TRANS/WP.29/GRSG/64  
3 December 2003

**REPORT OF THE WORKING PARTY ON GENERAL SAFETY PROVISIONS (GRSG)  
ON ITS EIGHTY-FIFTH SESSION**

(21 to 24 October 2003)

"Figure 6b

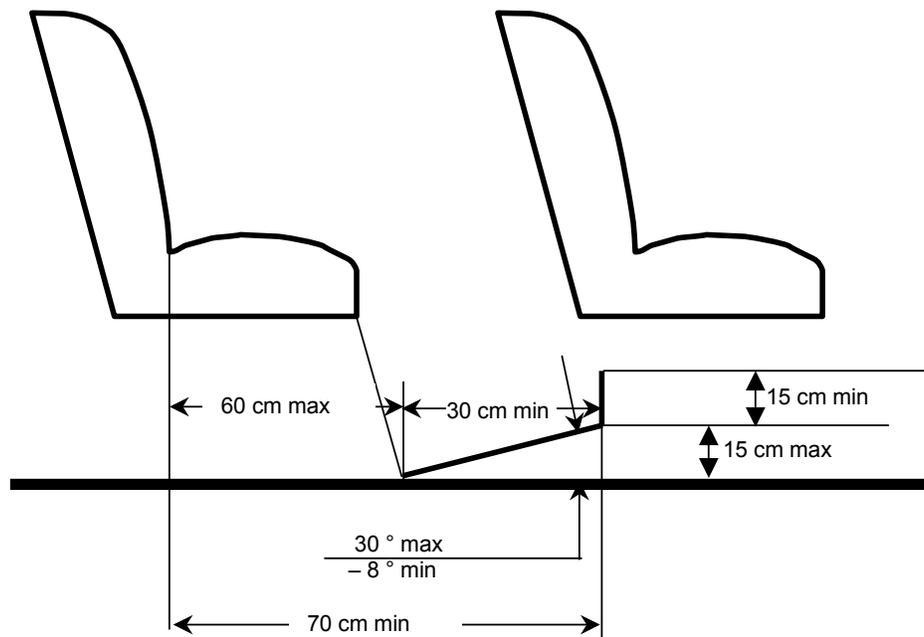
Insert a new figure 6b, to read:

SPACE FOR SEATED PASSENGERS BEHIND A SEAT AND/ OR A SEAT FACING THE  
GANGWAY  
(see paragraph 5.7.8.5.2)

"5.7.8.5.2. For a seat behind a seat and/or a seat facing the gangway, a minimum clear foot space of at least 300 mm depth and a width according to paragraph 5.7.8.1.1., shall be provided as shown in annex 3, figure 6b. The local presence in this space of seat legs and of intrusions as provided by paragraph 5.7.8.6.2.3. shall be permitted provided that adequate space remains for the passengers' feet. This foot space may partly be situated in and/or above the gangway but shall not create any obstruction when measuring the minimum gangway-width in accordance with paragraph 5.7.5."

"Figure 15b

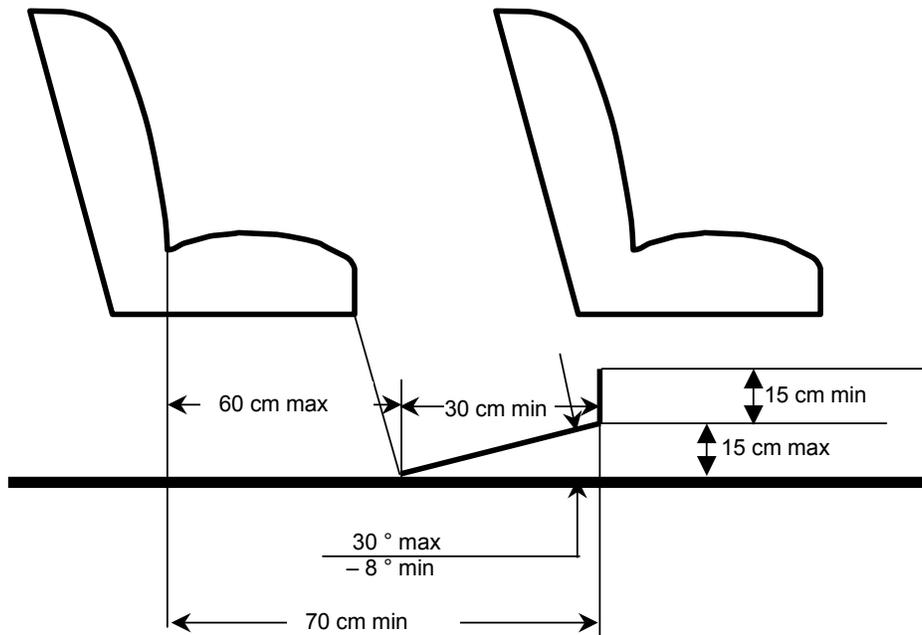
Insert a new figure 15b, to read:

SPACE FOR SEATED PASSENGERS BEHIND A SEAT AND/ OR A SEAT FACING THE  
GANGWAY  
(see paragraph 5.7.8.5.2.)

"5.7.8.5.2. For a seat behind a seat and/or a seat facing the gangway, a minimum clear foot space of at least 300 mm depth and a width according to paragraph 5.7.8.2.1. shall be provided as shown in annex 3, figure 15b. The local presence in this space of seat legs and of intrusions as provided by paragraph 5.7.8.1.3.3. and 5.7.8.1.3.4. shall be permitted provided that adequate space remains for the passengers' feet. This foot space may partly be situated in and/or above the gangway but shall not create any obstruction when measuring the minimum gangway-width in accordance with paragraph 5.7.5. Intrusion of the seat belts and seat belt anchorages shall be allowed."
